SUBJECT: **Invitation for Bid # 11-0498-DS 2011 Lift Station Rehab Group 1**

ADDENDUM # 1

Date: February 11, 2011
To: All Bidders
Subject: FY 2011 Lift Station Rehabilitation - Group 1
Project No.: 402.0019707

Subject: IFB# 11-0498-DS---2011 Lift Station Rehab Group 1 - Response to Bidders' Questions

FY 2011 LIFT STATION
REHABILITATION GROUP 1
ROSEDALE HIGHLANDS 1 (RTU 387)

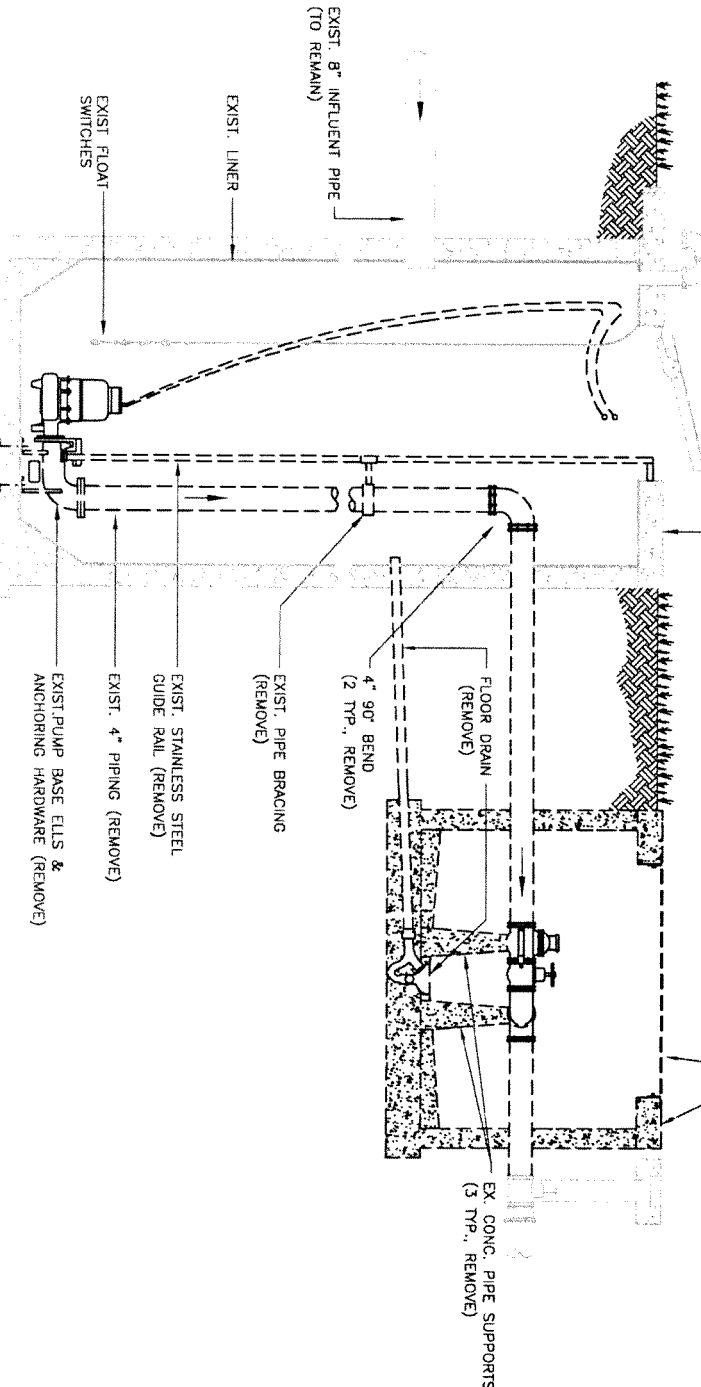
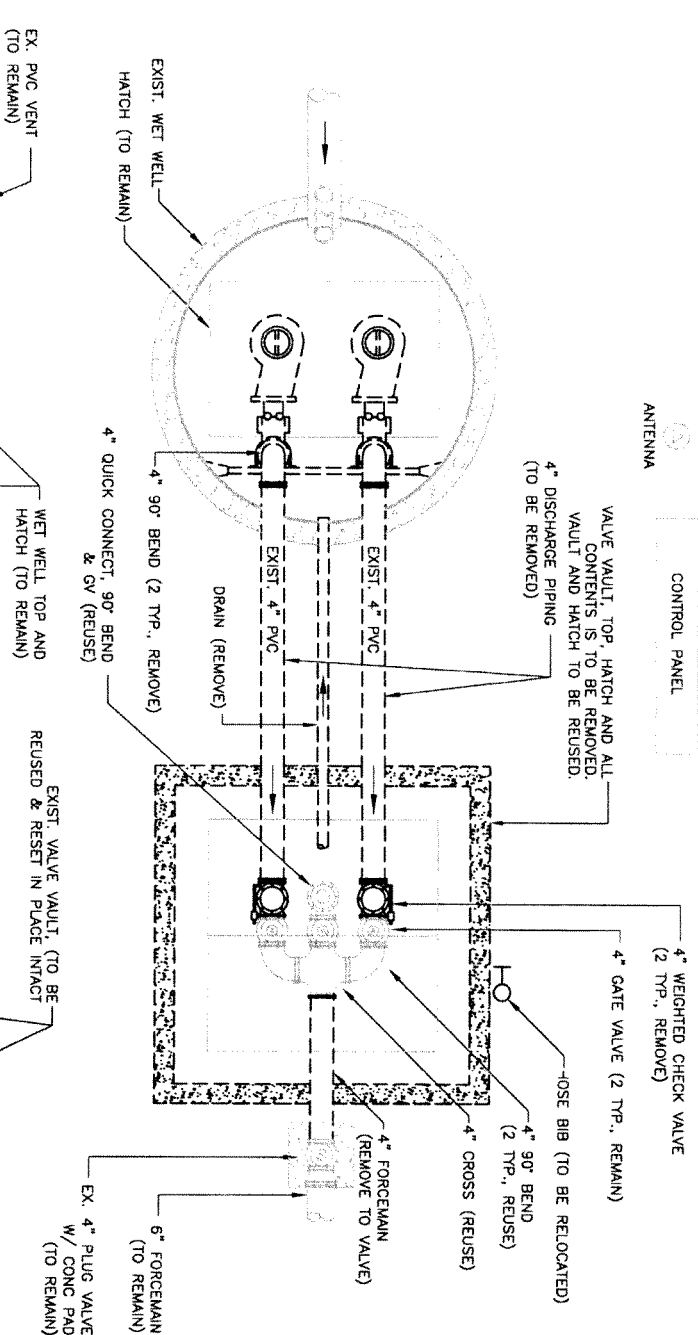
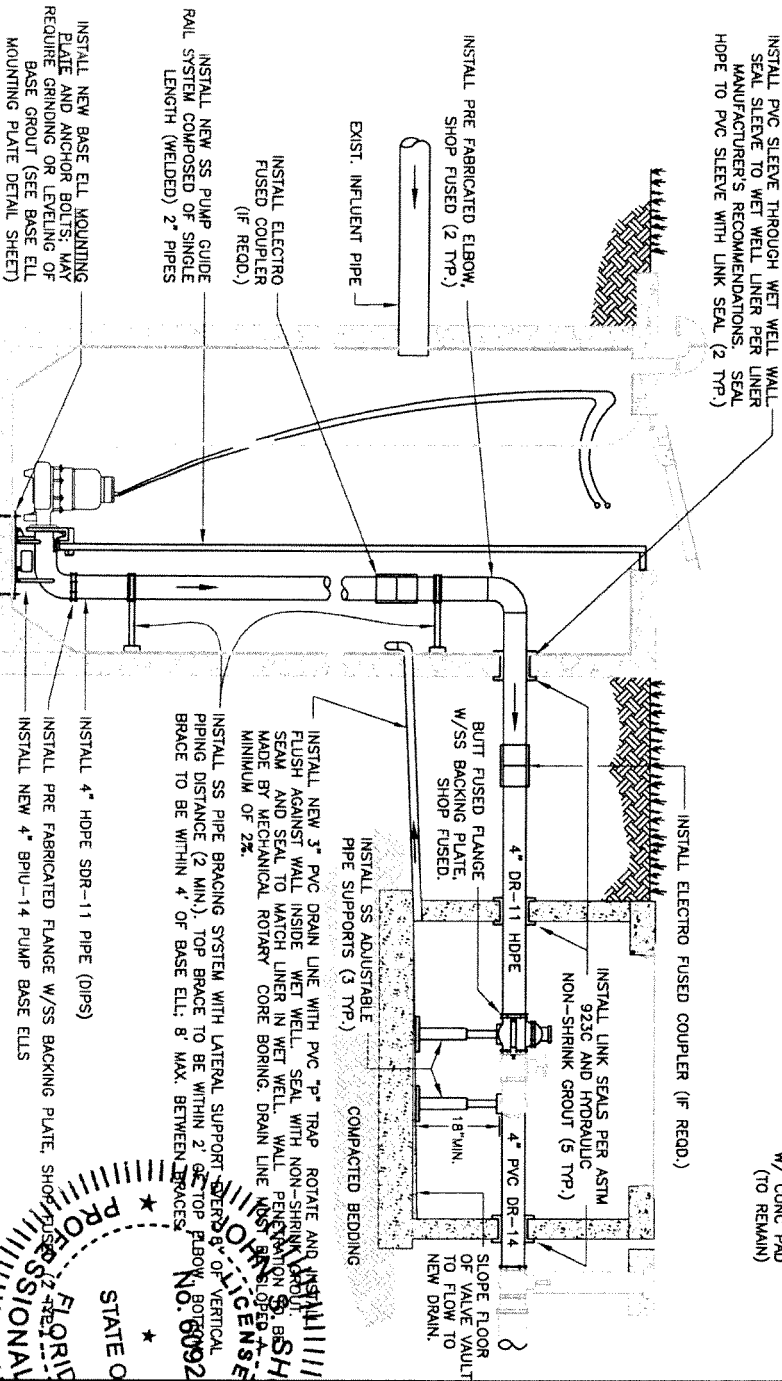
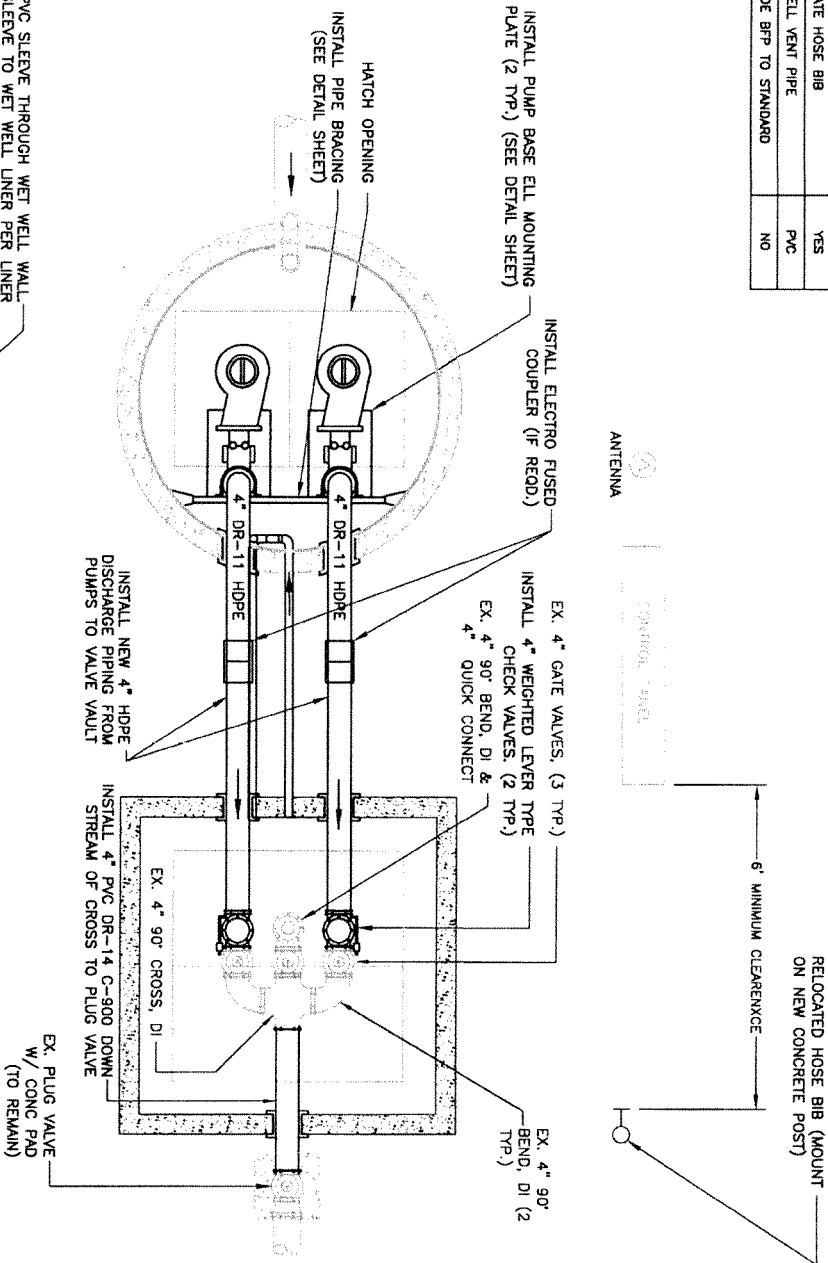
Rosedale: deleted line # 21. No new ductile iron fittings proposed on the plans. Plan sheet was revised.

1. **Question:** On the drawing for the Rosedale Highlands Lift Station there are notes which indicate that the 4" gate valves in the vault, along with the existing 90 and Quick-Connect, are to be reused. However, the measurement and payment section relating to the valves specifically states that the contractor is to furnish and install the valves. This lift station is the only one that says to "reuse" the existing valves and I have a feeling this may be a typo on the drawings. Please advise.

Response: The plan sheet has been revised. The existing gate valves, quick connect, and fittings inside the valve vault shall remain and be reused or re-installed back into the valve vault. The bidders shall include their cost for removal and installation of the existing gate valves, quick connect, and fittings inside the valve vault under the Miscellaneous Work Bid Item # 37.

NO.	REVISION DESCRIPTION	BY	DATE
1	REVISION GATE VALVE & FITTINGS (REUSE)	JSS	2/8/11
